DEVELOPMENT NO.:	21025191
APPLICANT:	Hayden Doak
ADDRESS:	5 SEAVIEW TCE BRIGHTON SA 5048
NATURE OF DEVELOPMENT:	Two storey detached dwelling with associated garage located on the southern boundary and swimming pool, verandah, retaining walls and fencing at the rear
ZONING INFORMATION:	Zones: <ul style="list-style-type: none"> • General Neighbourhood Overlays: <ul style="list-style-type: none"> • Airport Building Heights (Regulated) • Affordable Housing • Prescribed Wells Area • Regulated and Significant Tree • Stormwater Management • Urban Tree Canopy
LODGEMENT DATE:	29 Aug 2021
RELEVANT AUTHORITY:	Assessment panel
PLANNING & DESIGN CODE VERSION:	12 August 2021 2021.11
CATEGORY OF DEVELOPMENT:	Code Assessed - Performance Assessed
NOTIFICATION:	Yes
RECOMMENDING OFFICER:	Dean Spasic Development Officer - Planning,

DETAILED DESCRIPTION OF PROPOSAL:

The proposed development is for the construction of a two storey detached dwelling with rear verandah, swimming pool, retaining and fencing.

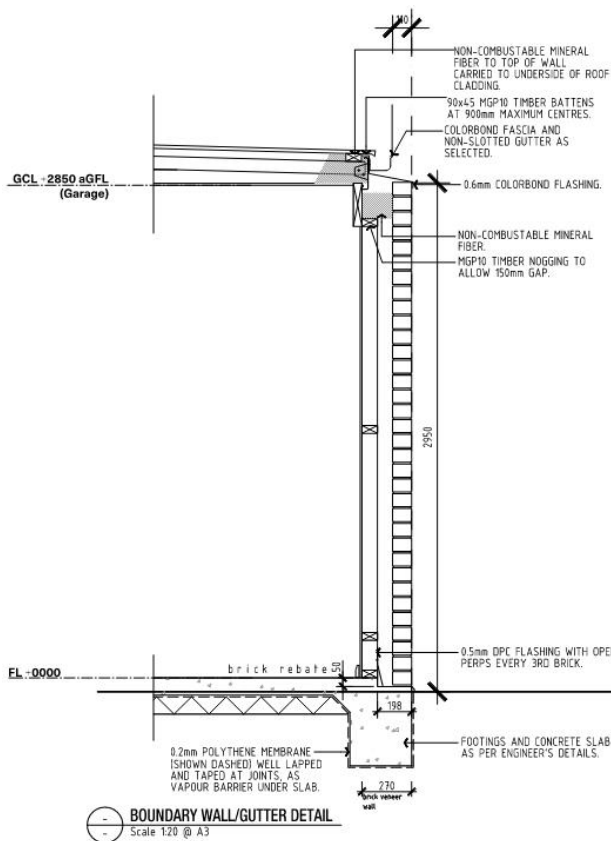
- Di and Jim Roennfeldt of 35 Marlborough Street expressed concern with the staircase window not shown as obscured. A condition of consent is included requiring all side and rear upstairs windows to be obscured to a height of 1.5 metres;
- Professor N Naffine of 7 Seaview Terrace, expressed a number of concerns including garage height on southern boundary, fencing and retaining, visual privacy, height, bulk and scale and the siting of the pool pump.

- In response to the representations, the applicant submitted a set of plans seeking to alleviate the concerns raised by the neighbour. This included a garage wall detail which demonstrates that the wall height is not more than 3 metres on the boundary, with the flat roof comprising any remaining height and the introduction of a screen adjacent to the southern elevation of the terrace, in order to mitigate overlooking concerns immediately south, as per the images below:

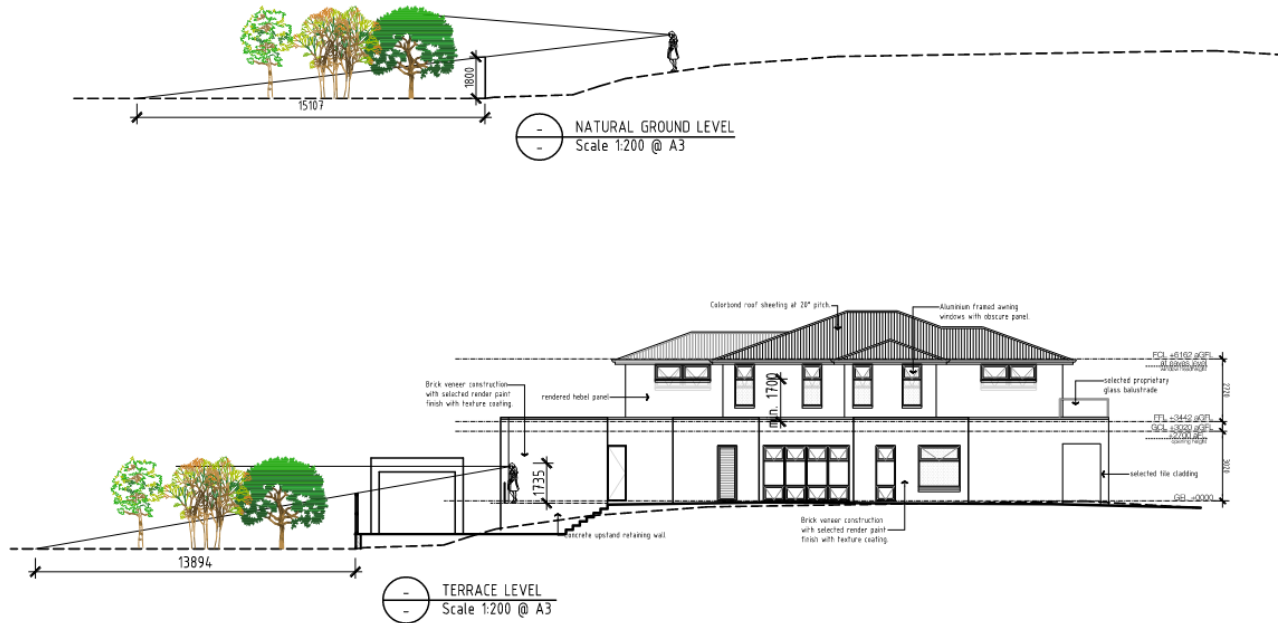
As per the Line of Sight Plan found in Attachment 1 (and below), the topography of the land is such that there is a drop to the rear of the site, which results in overlooking into neighbouring yards. The proposed development will result in finished levels that are similar to the line of sight currently experienced, hence, on balance visual privacy from ground level will be largely unchanged. The applicant has opted to include a free standing screen adjacent to the southern side elevation of the terrace to prevent any direct views into the southern adjacent property. As per the Line of Sight Plan, the proposal has achieved the Performance Outcome 31.2 objective, which is to minimise impacts on privacy. In comparison with the current extent of overlooking, the proposal has reduced the degree of overlooking.

The photos below show the current view achieved from the existing finished floor level, which is 100.56 (260mm higher than the proposed dwelling floor level (100.30)), and therefore an improvement on the existing situation:
